**U.S. NUCLEAR REGULATORY COMMISSION SAFETY
EVALUATION REPORT FOR THE HIGH ASSAY LOW
ENRICHED URANIUM DEMONSTRATION PROGRAM
AT CENTRUS ENERGY CORP./AMERICAN
CENTRIFUGE OPERATING, LLC's AMERICAN
CENTRIFUGE PLANT IN PIKETON, OHIO**

DOCKET NUMBER 70-7004

LICENSE NUMBER SNM-2011

June 2021

Figure 1 – Critical masses of homogeneous water-moderated U(93.2) spheres. (LA-10860-MS)

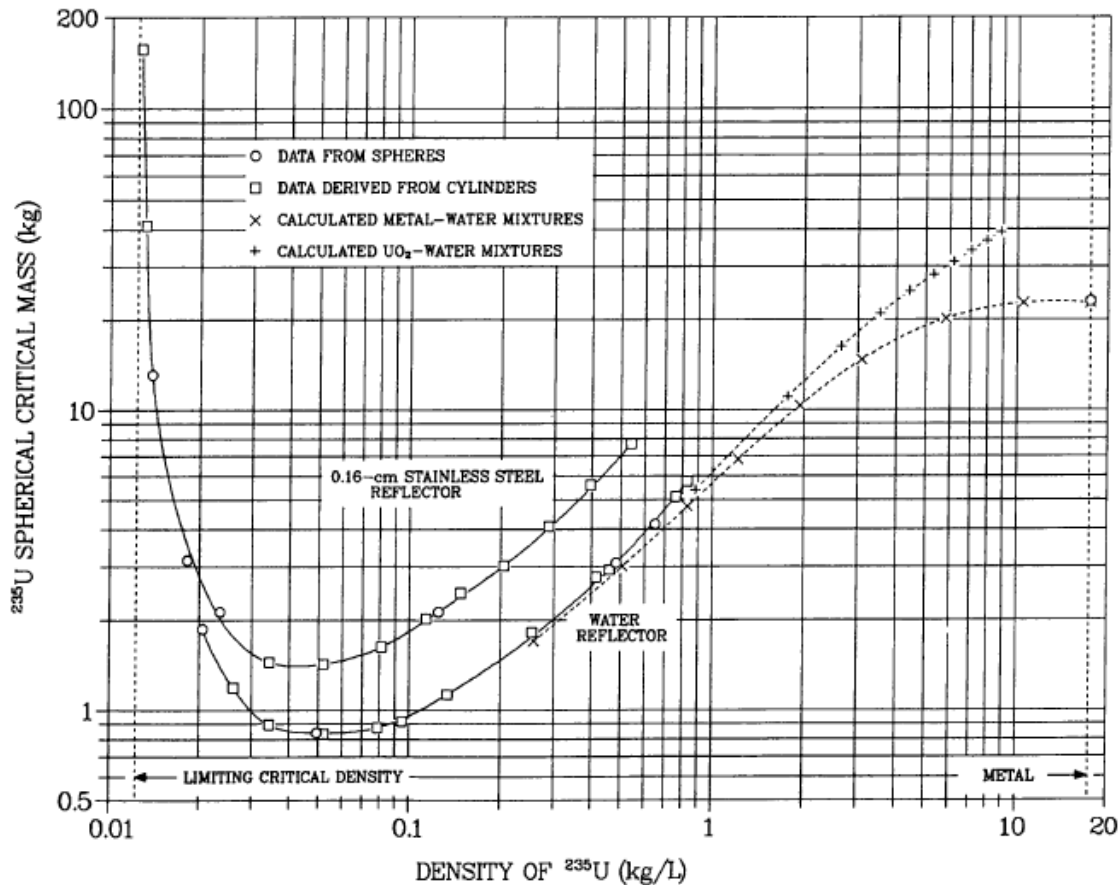
Based on a review of LA-10860-MS critical mass plots (Figure 1), the staff determined that the minimum critical mass for U-235 is approximately 764 grams. This value represents the absolute minimum mass required for criticality under the worst-case conditions for each NCS parameter (93.2 wt.% enrichment, spherical geometry, U-metal composition, optimum interstitial moderation, full light-water reflection, etc.). The staff also reviewed ANSI/ANS-8.1, which identified a minimum critical mass of approximately 760 grams for uranyl fluoride solutions. Given that these values represent the absolute minimum critical mass and that the normal and credible abnormal conditions associated with ACO operations are far less reactive (e.g., under-moderated ≤ 25 wt.% enrichment), the staff determined that the factor of 7 stated in the proposed change is technically conservative and consistent with reputable technical references and NRC-endorsed standards (ANSI/ANS-8.1), and is, therefore, acceptable.

Figure 2: Estimated prompt dose for 93.2 wt.% uranyl nitrate (left) and 4.95 wt.% uranyl fluoride (right) 10^{17} fissions.

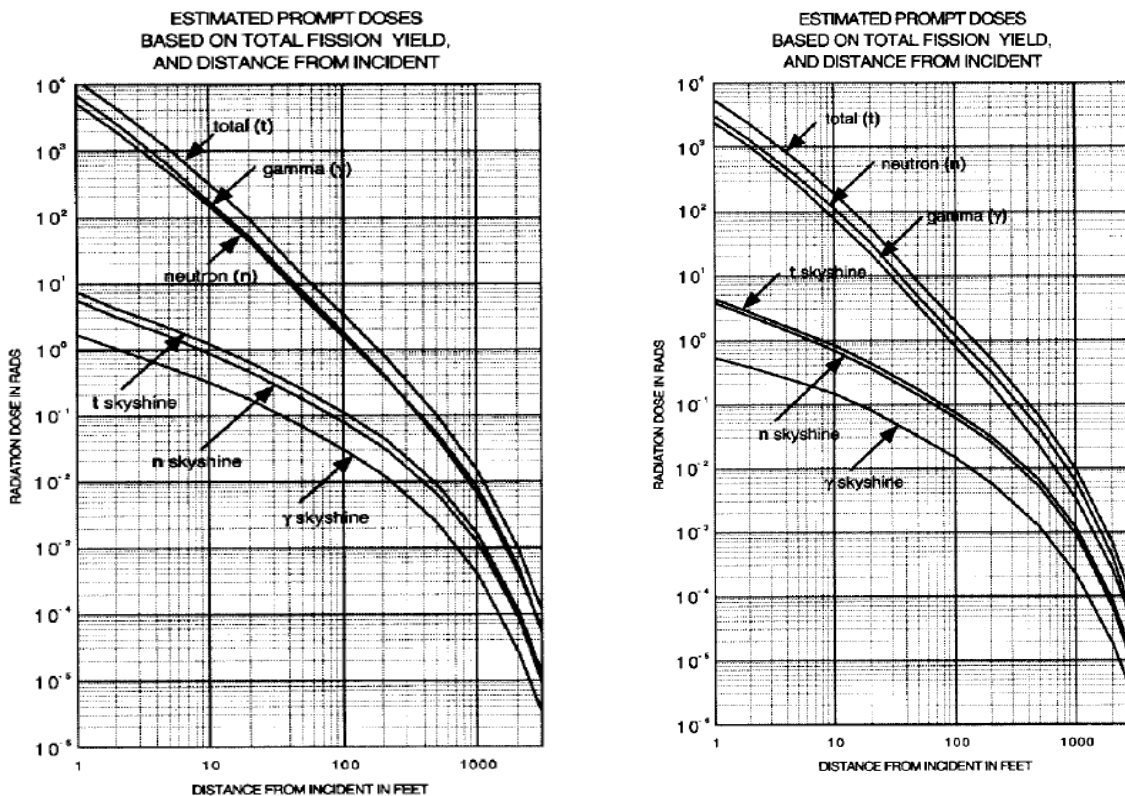
From review of Figure 2, as shown in Table 1, the staff noted that the dose from a system representative of ACO's operations (20 wt.% UF₆ or uranyl fluoride) would be somewhere between 0.5 and 0.4 rad at a distance of 125 feet. The values derived from NUREG/CR-6504 provide reasonable support to conclude that the dose at 125 feet (0.5 rad which is at most 10 rem¹) would be far less than the 100 rem and 25 rem total effective dose equivalent to the
